Camellia and Rosehill Recycled Water Scheme

Preferred Project Report

Date: 19 March 2009
Reference: RRW-01-RP-E-00031
Revision: 0

Figure 2-1 Revised and original layouts for Fairfield water recycling plant

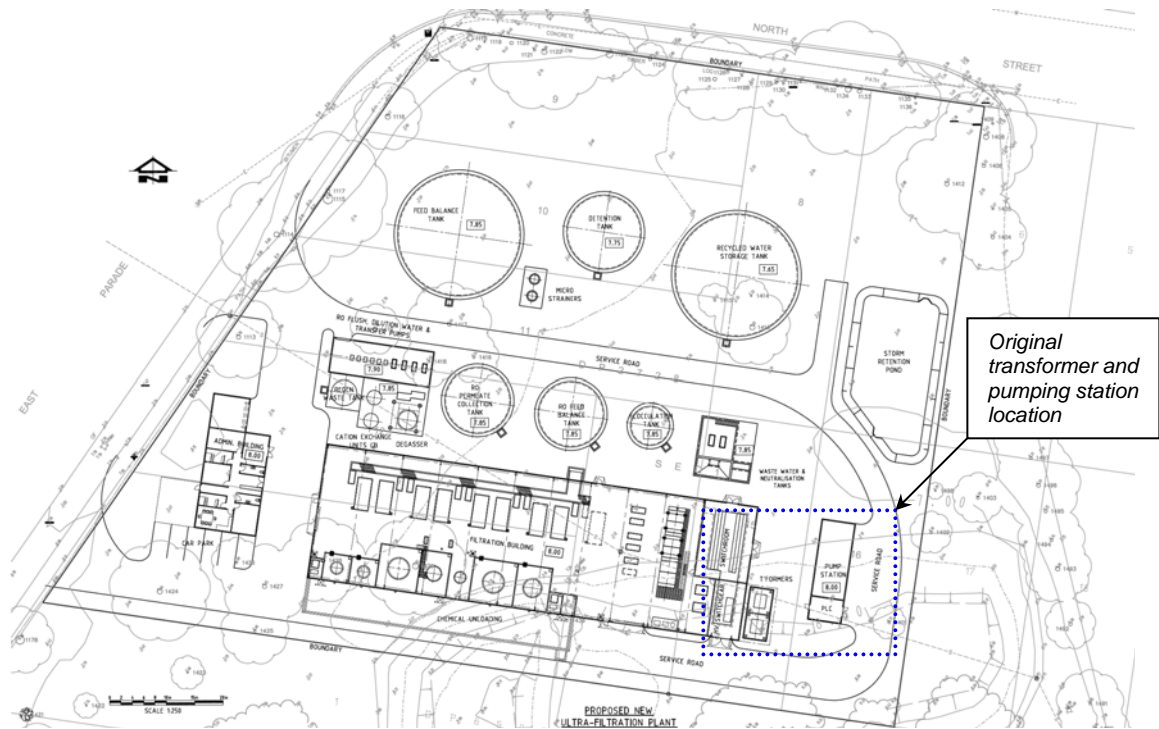
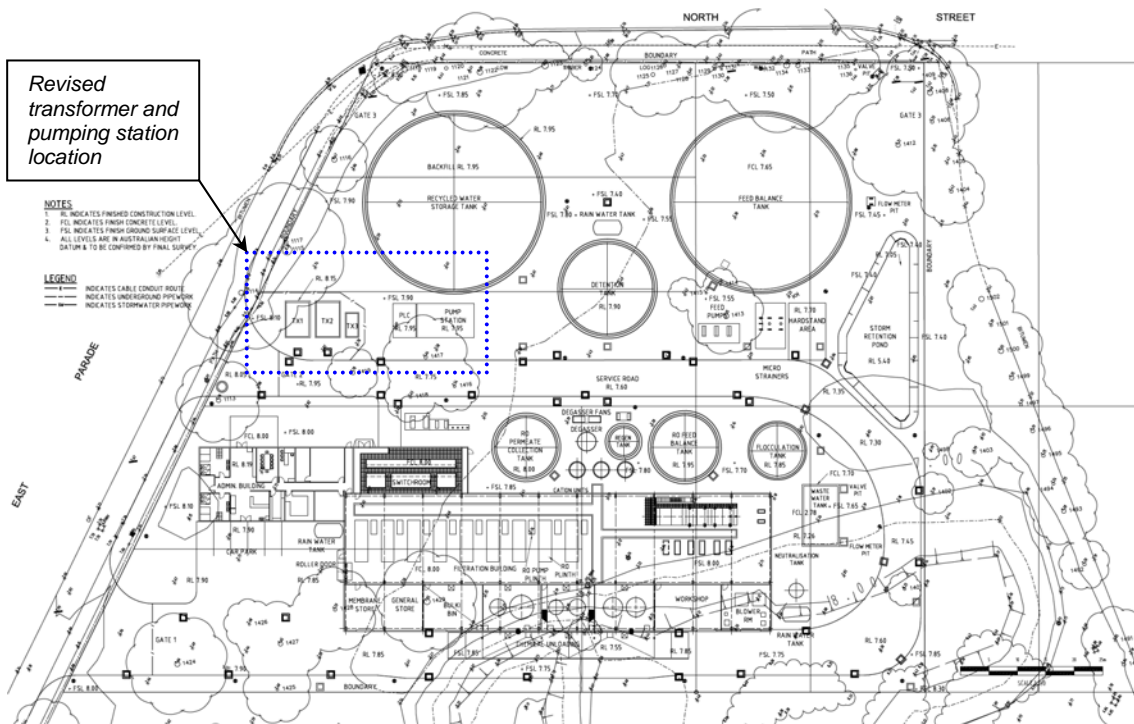
The plant design has been advised to accommodate the requirements of the energy provider. The original proposal included a high voltage transformer located immediately east of the main filtration building in the south eastern portion of the site. The revised design now includes three low voltage transformers (2 x 1250kVA and 1 x 500kVA) located on the western boundary of the site off East Parade. The revised transformer location and configuration is outlined in the revised plant design plans shown in **Figure 2-1** below. A detailed plan of the revised plant layout is provided in **Appendix A**.

The revised location has been chosen in between the recycled water storage tank and the main filtration building directly adjacent to the transformer as shown in **Figure 2-1** and **Appendix A**. At this location, line of sight between the pump station and the residences is limited by recycled water storage tank, detention tank and feed balance tank, providing noise attenuation for the adjacent residents along North Street.

Due to the relocation of the transformers and the pumping station, a change to the plant layout was required in order to maintain sufficient clearance between the various plant components. The numbers and type of components has remained the same. However, the configurations and dimensions of structures have changed.

In order to reduce energy requirements the heights of the recycled water storage tank, feed balance tank and detention tank have been reduced. To maintain storage volumes, the diameters of the tanks have increased accordingly, as shown in the revised plant layout plan **Appendix A**.

Figure 2-2 Revised and original elevations for Fairfield water recycling plant

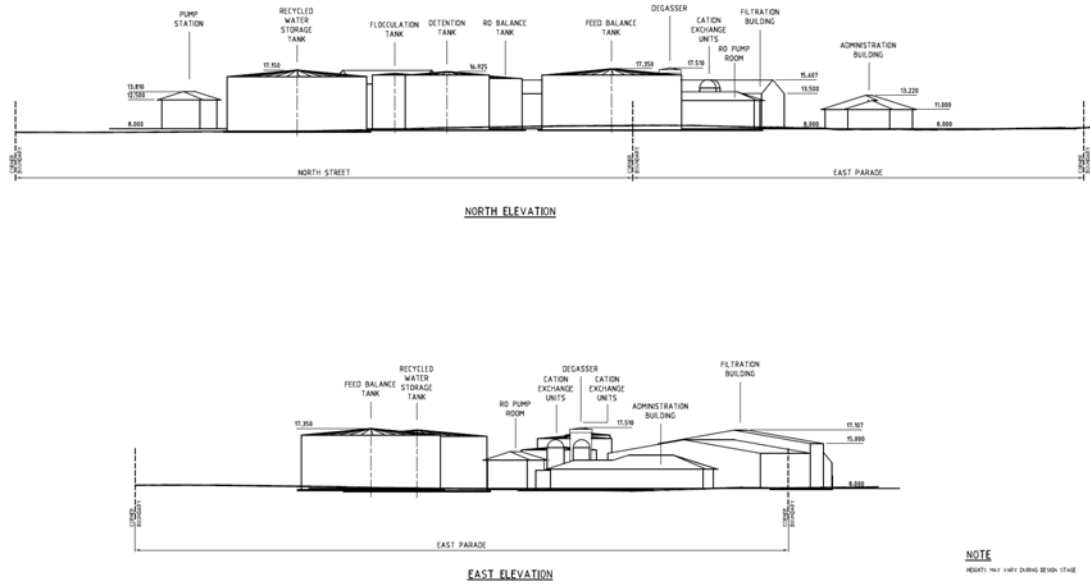
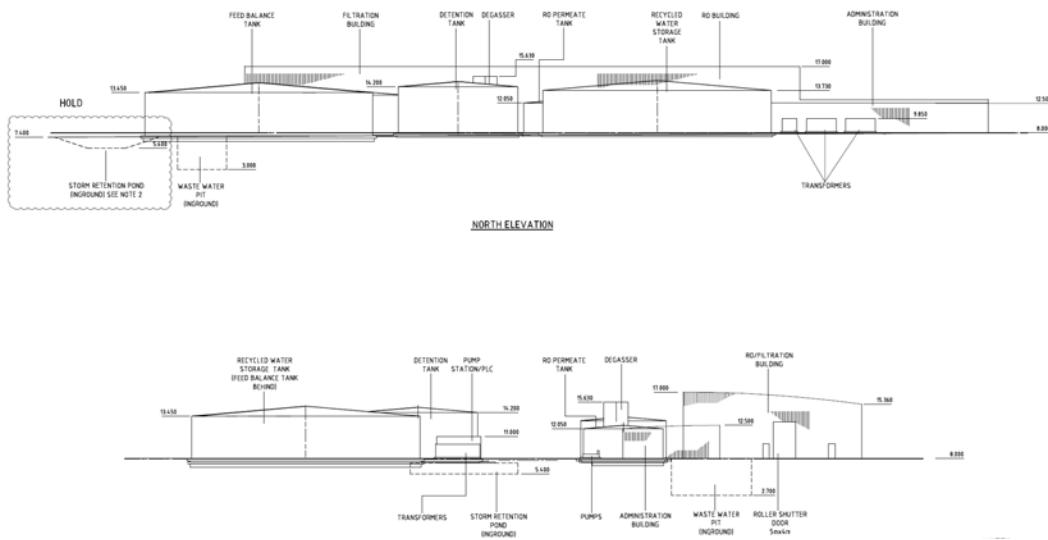
The revised layout potentially affects the visual amenity of the site. In general, the heights of all the tanks, buildings and other structures proposed at the Fairfield water recycling plant have been reduced in the revised design, and the overall silhouette of the plant will be more compact. The original and revised section plans are shown in **Figure 2-2** below. A revised elevation plan for thee plan is provided in **Appendix A** of this report. A summary of revised heights and height changes is provided in **Table 2-1** below.

Figure 2-3 Revised distribution pipeline alignment on North Street, Fairfield

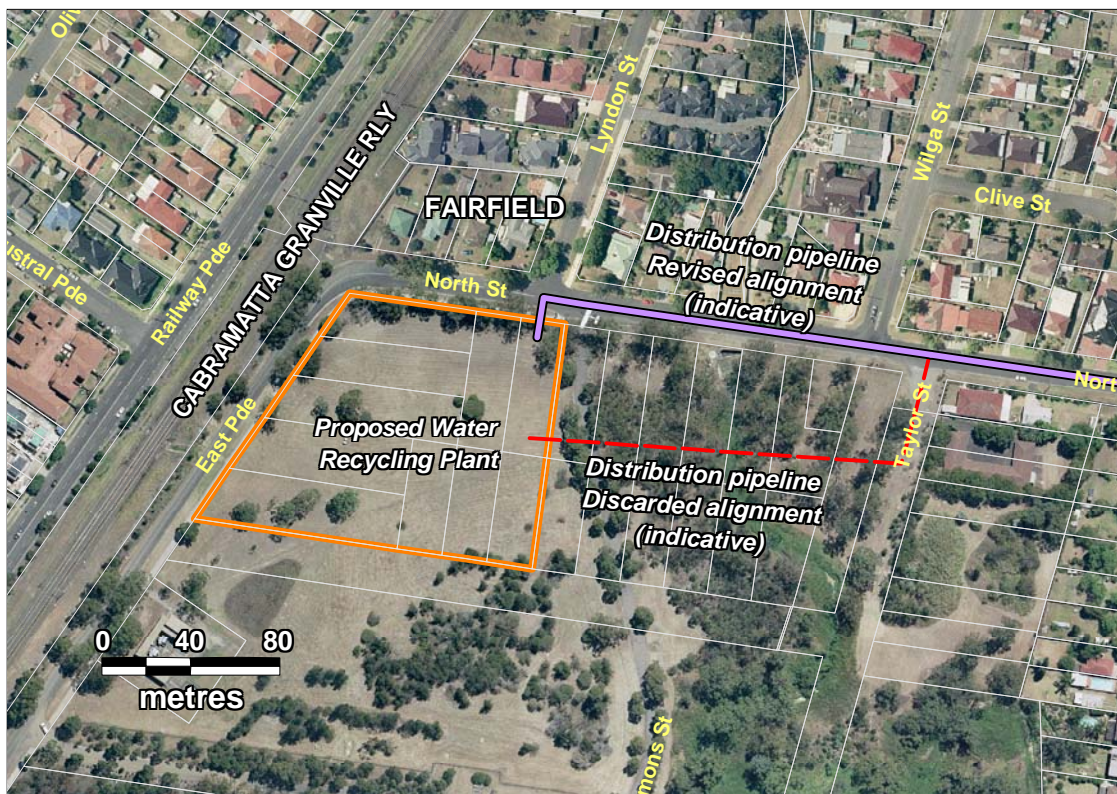
Figure 3-12 in the Environmental Assessment indicates the proposed alignment of the distribution pipeline traversing due east as it exits the proposed plant at North Street, Fairfield through an area featuring a stand of significant native vegetation associated with the riparian zone along a unformed drainage line running south from North Street (St Elmo's Drain) before intersecting with Taylor Street, Fairfield.

In consideration of the conservation and biodiversity significance of this location and the potential impacts to the native vegetation, the riparian corridor and the watercourse this proposed alignment has now been modified.

The revised proposal adopts an alignment directly north out of the proposed plant site into the North Street road corridor. The distribution pipeline would then be constructed entirely within the road corridor of North Street in an easterly direction. The pipeline would be installed underneath the box culvert that conveys stormwater underneath North Street via a cased thrust bore. The revised alignment is shown in **Figure 2-3**.

The revised alignment avoids potential impacts to significant trees and other vegetation associated with the riparian corridor to the south of North Street between the proposed site location and Taylor Street. A number of existing smaller trees and shrubs (planted) along the boundary of the proposed site may require removal at the location where the distribution pipeline would leave the plant site. However, the crossing location shall be chosen to avoid impacts to the significant eucalypts currently located along the boundary line.

Figure 4-4 Location of St Elmo's Drain at proposed development site

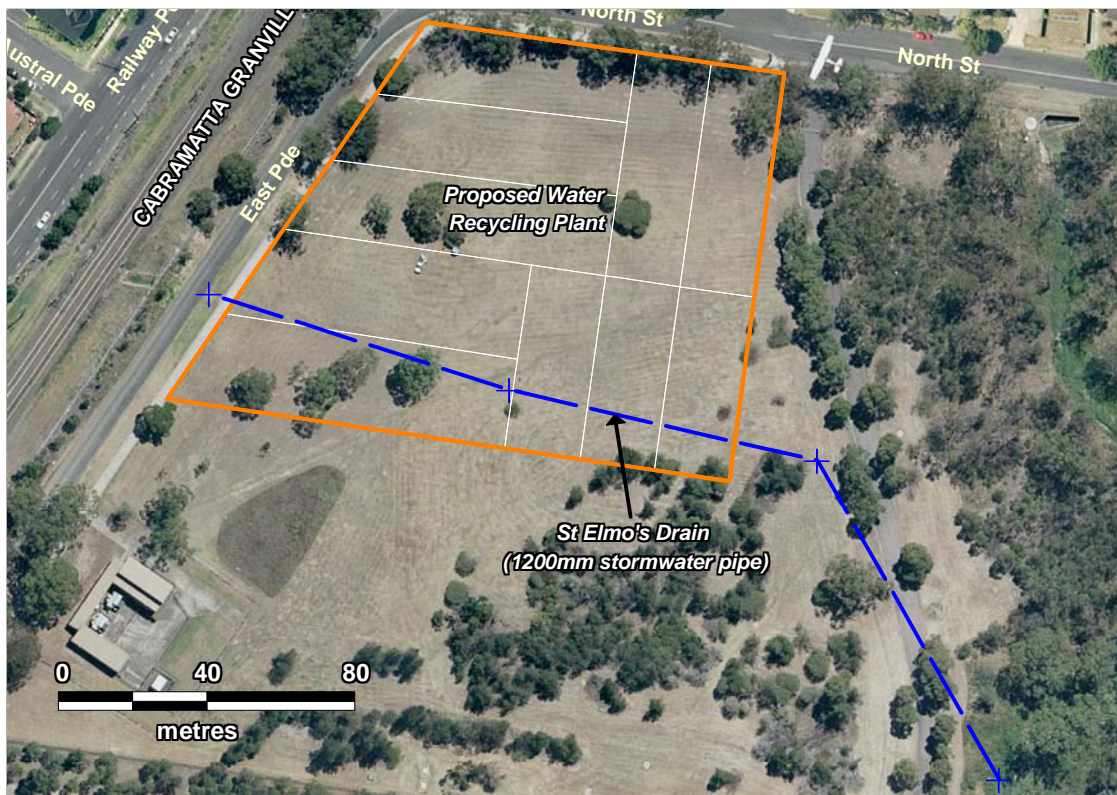
During consultation with Fairfield City Council during the exhibition period, it was identified that a large and significant stormwater drain, referred to by Council as 'St Elmo's Drain', crosses the proposed site of the Fairfield water recycling plant. Council indicated that the drain was a 1200mm diameter concrete stormwater pipe that traverses the site in an east-west direction. However, the exact location of the drain was not known to Council. The pipe conveys stormwater collected from significant catchment to the west of the railway line across the site and into the unformed vegetated drainage line to the east of the proposed development site. Council identified that the drain conveys significant volumes of water during storm events and that the asset is critical to stormwater management in the area.

An internal inspection of the stormwater drain was undertaken on 25 February 2009. A remote-controlled device was passed along the inside of the drain from the upstream end and the location of the device tracked. From the information collected, the exact location of the drain was identified and is shown in **Figure 4-4**.

From the investigation it was identified that the drain passes directly underneath the proposed location of the main filtration building of the water recycling plant and that options for relocating the drain would need to be considered. Relocation of the stormwater drain is discussed further in **Section 5.2**.

Figure 5-1 Distances of closest residential receptors to chemical storage area

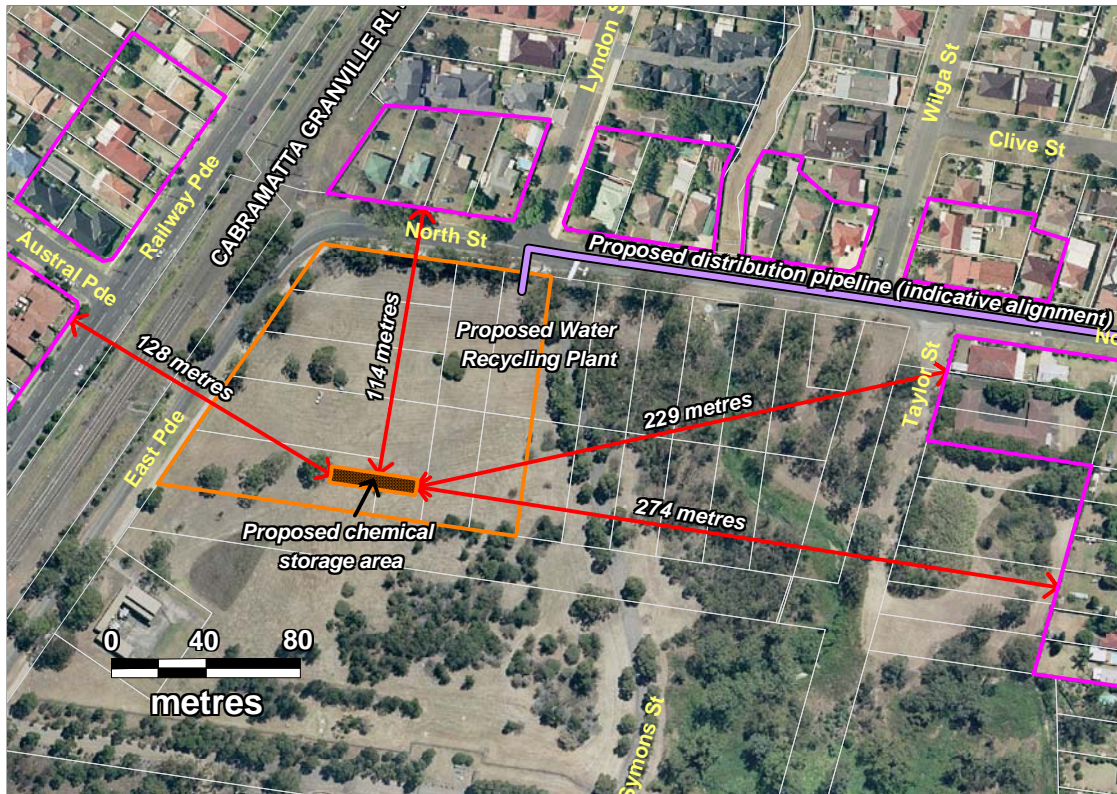
Fairfield City Council raised concerns regarding the potential for the generation and release of chlorine gas in significant volumes due to the potential for mixing and reaction between the acids and hypochlorite stored at the Fairfield water recycling plant. Furthermore, Fairfield City Council indicate that based on the risk of chlorine gas generation and the potential for major offsite impacts a quantitative preliminary hazard analysis, rather than the qualitative preliminary hazard analysis presented in the Environmental Assessment, is more appropriate.

Additional information from the plant designers was sought on design and procedural controls proposed to address this issue. The risks of chemical reaction and the generation of significant volumes of chlorine gas have been considered and are mitigated at design and operation level. Whilst insignificant (trace) volumes of chlorine gas could emanate from the plant during hypochlorite dosing of the recycling process, any impacts would be limited to the immediate vicinity of the dosing location. Significant volumes of chlorine gas could not be generated and no off-site impacts would be likely. Additional information regarding chlorine gas generation minimisation is outlined below:

The potential for generation of significant volumes of chlorine gas at the chemical storage area is actively managed via both design and procedural controls, in accordance with AS 3780-1994 *The storage and handling of corrosive substances*. As such, the potential for major and widespread off-site impacts associated with chlorine gas generation is limited. Therefore, the qualitative preliminary hazard analysis presented in the Environmental Assessment is considered sufficient and no quantitative preliminary hazard analysis is required.
